PART 573 Defect **Report**

Accubuilt Incorporated Modified Chrysler 300 series LWB vehicles modified, certified and shipped by Accubuilt from November 9th, 2006 through January 9th, 2007.

Generic name of the item: Park Brake Cable

Subject: Accubuilt Safety Recall # 07-001

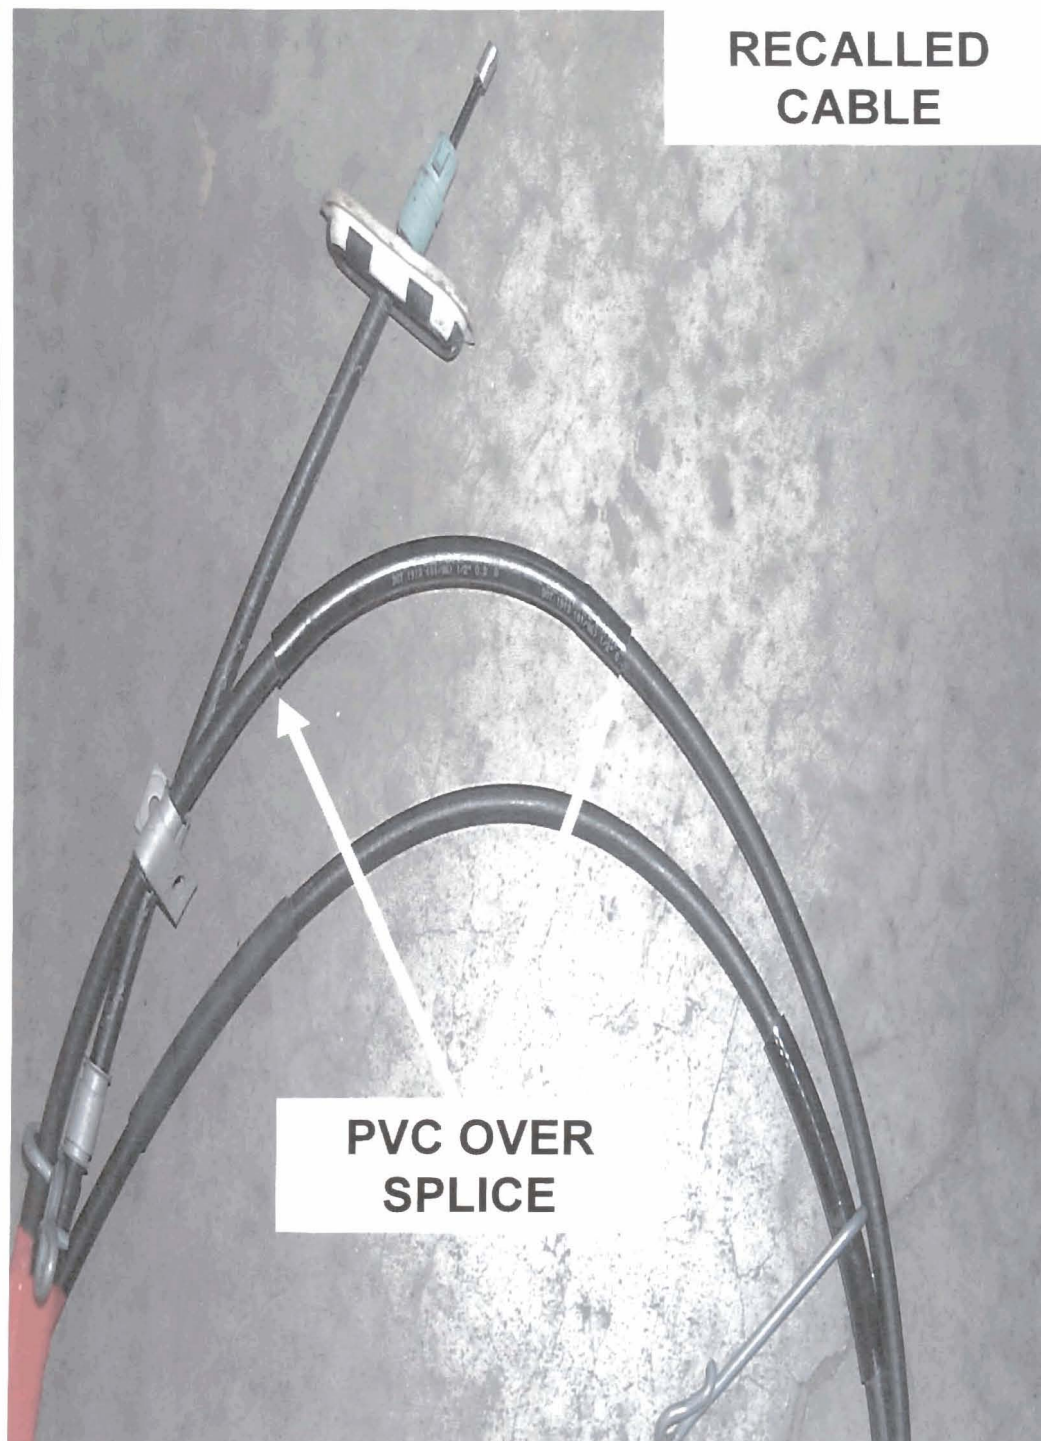
The defect is a park brake cable which contains a spliced outer sheath, elongated by (6) inches, Accubuilt part number 96415439.

The cable connects to the park brake pedal assembly at the left kick panel, left of the service brake pedal and runs rearward through the floor pan underneath the vehicle attached to the left side underbody, and connects to the rear cable assembly near the left side of the rear axle. The splice in the outer sheath is seen as a raised section of PVC, slightly larger than the cable diameter for a length of approximately 8 inches, located just forward of the "B" pillar (between the front and rear doors).

The cause is a supplier modification and splicing process, which may fail to meet the compressive loads required to maintain cable tension. The spliced outer sheath may collapse under compressive load.

The remedy cable has a one piece, continuous outer sheath, whereas the recalled cable has a splice near the middle section of the cable. The remedy component has a ring of green tape just forward of the former splice location on the recall cable.

The remedy is to replace the old cable with the new part number cable.

The new cable holds tension, enabling the park brake system to hold the vehicle as required. The recalled cable will not always transmit adequate tension to adequately hold the vehicle.

REPLACE THE PARK BRAKE CABLE WITH ACCUBUILT P/N **96415852**. NEW PARK BRAKE CABLES AND INSTRUCTIONS HAVE BEEN SUPPLIED FOR THE VEHICLES LISTED IN THIS LETTER. THE NEW CABLE WAS PUT INTO PRODUCTION AT ACCUBUILT ON 1/19/2007.
